SITE PLAN
DEPOT STREET BUILDING
OWNER/DEVELOPER: NANCY BROWN
TOANO JAMES CITY COUNTY VIRGINIA

RE: Site Plan
Depot Street Building
AES Project No. 6355

SUBJECT: **Case Number** SP-5-87

DEPOT STREET BUILDING
AES PROJECT NO. 6355

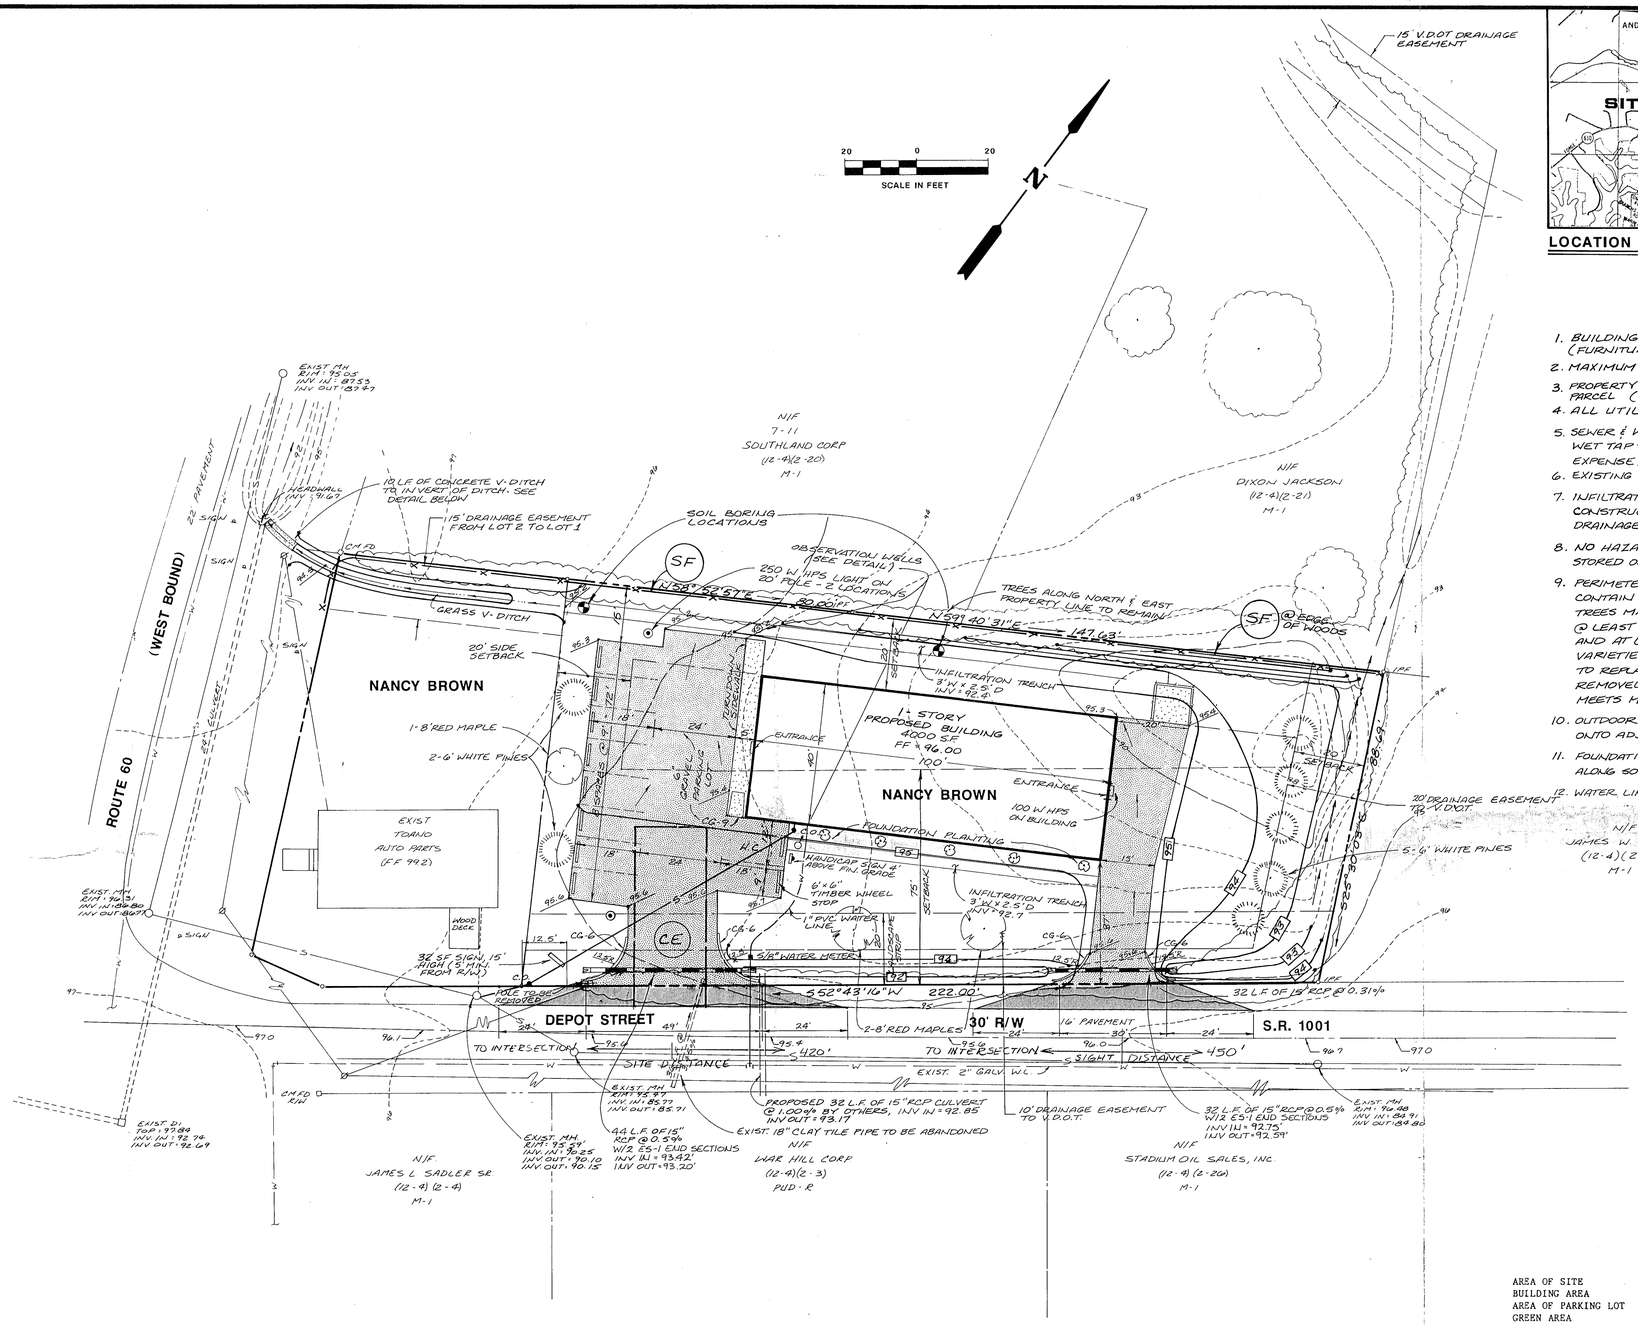
1. A Land Disturbing Permit and Siltation Agreement, with surety, are required for this project.
2. A copy of the recorded drainage easement for the project to Richmond Road must be provided prior to final site plan approval.
3. The Inspection/Maintenance Agreement for the runoff control facilities must be executed prior to final site plan approval.

3. We do not understand why we need to comply with the Highway Department's request to provide a standard curb section and 25 foot radius for this project. Because of the narrowness of the right-of-way and lack of depth of the site, none of the entrance is on highway right-of-way. It is contained entirely on private property and if we use the 25' radius, we would use 1/3 of the depth of the site to provide entrances to the project. We request that the Highway Department approve the entrances as shown, since none of the entrance is on the highway right-of-way.

No.	DATE	REVISION / COMMENT / NOTE	BY
4	3/14/88	ADDED SIGHT DISTANCE	RAC
3	1/22/88	REVISED PER V.D.O.T.	RMS
2	12/87	REVISED PER J.C.C. & V.D.O.T.	RMS
1	11/2/87	REVISED PER OWNER	RAC

1. We have added the route number for Depot Street.

2. Site distance has been documented on the plans. The road is only 850' in length, therefore 35 mph is probably the maximum speed that can be achieved from either end.

2. We have added the property parcel number to the general notes.

3. We have added two additional trees along the southeast property line.

INFILTRATION TRENCH

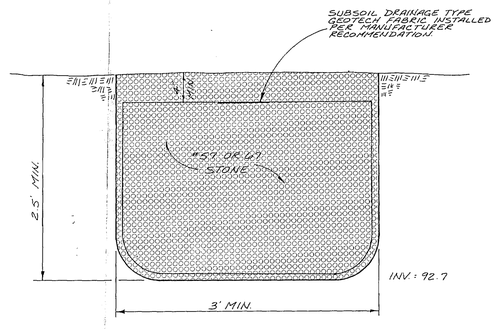
1. A Land Disturbing Permit application shall be filled out + returned.
2. A Siltation Agreement, with $3500 security, shall be executed prior to issuance of a Land Disturbing Permit.
3. Provide evidence (soil test) that the soils have the ~~#~~ infiltration rate stated in the Runoff Analysis.
4. Provide a note that states the infiltration trench will not constructed until contributing drainage areas have been stabilized.

1. A Land Disturbing Permit and Siltation Agreement, with surety, are required for this project.
2. Provide results of a soils test that verifies that the soils ~~have the~~ ~~are~~ ~~suitable for~~ have the infiltration rate stated in the Runoff Analysis.
3. Project has been reduced in scope resulting in less impact on the Ware Creek Reservoir. Therefore, the Runoff Analysis will not have to be revised.

3. Recommendations for additional control measures if required, including monitoring.

COUNTY OF JAMES CITY
FINAL SITE PLAN

3. Included is a soils study from our consultant, Larry Madison - Soil Scientist, for the soils at this site in the vicinity of the infiltration trench.

The first recommendation of Item No. 3 shall be accomplished by adding a note to the plan relating to delaying construction of the infiltration trench. The soil test shall be provided prior to final site plan approval.
